# Access Compliance Report

## Public Rights-of-Way

Intersection ID: 10033070	Main Street: NORTH_COMMUNITY_HOUSE_RD	Cross Street: N/A	Location: SW
ADA ID: 1E06B475CAEB	Ramp Type: Perp	Initial Pass/Fail: Fail	Overall Compliance: No
Severity Score: 25			
Codes/Mitigation Info/Possible Solution		Field Measurements/Component Compliance

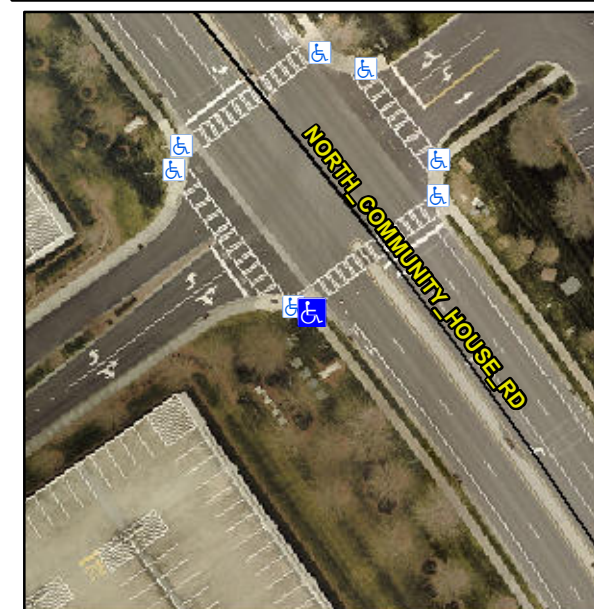
**Not Found, R304.2.2, R304.5.3**

Compliance	Description	Data	Compliance	Description	Data
N/A	Ramp Length (in)	24.0	No	Ramp Slope (%)	10.0
Yes	Ramp Width (in)	48.0	No	Ramp XSlope (%)	6.6
N/A	Flare Type LT	N/A	N/A	Flare Type RT	N/A
N/A	Flare Slope LT (%)	N/A	N/A	Flare Slope RT (%)	N/A
N/A	Flare Traversable LT?	N/A	N/A	Flare Traversable RT?	N/A
N/A	Landing Length (in)	N/A	N/A	DWS Provided?	N/A
N/A	Landing Width (in)	N/A	N/A	DWS Contrast?	N/A
N/A	Landing Slope (%)	N/A	N/A	DWS Length (in)	N/A
N/A	Landing X Slope (%)	N/A	N/A	DWS Full Width?	N/A
N/A	Landing Curb? (Y/N)	N/A	N/A	DWS Offset (in)	N/A
N/A	Shared Landing?	N/A			
N/A	Gutter Ponding?	N/A	N/A	Gutter Slope (%)	N/A
N/A	Gutter Lip Ht (in)	N/A	N/A	Gutter X Slope (%)	N/A
N/A	Painted X Walk1?	Yes	N/A	Painted X Walk2?	N/A
	X Walk 1 Direction	To NE		X Walk 2 Direction	N/A
N/A	X Walk 1 Width (in)	111.5	N/A	X Walk 2 Width (in)	N/A
	X Walk 1 Slope (%)	3.9		X Walk 2 Slope (%)	N/A
	X Walk 1 X Slope (%)	2.5		X Walk 2 X Slope (%)	N/A

**Remove & Replace Entire Ramp.**
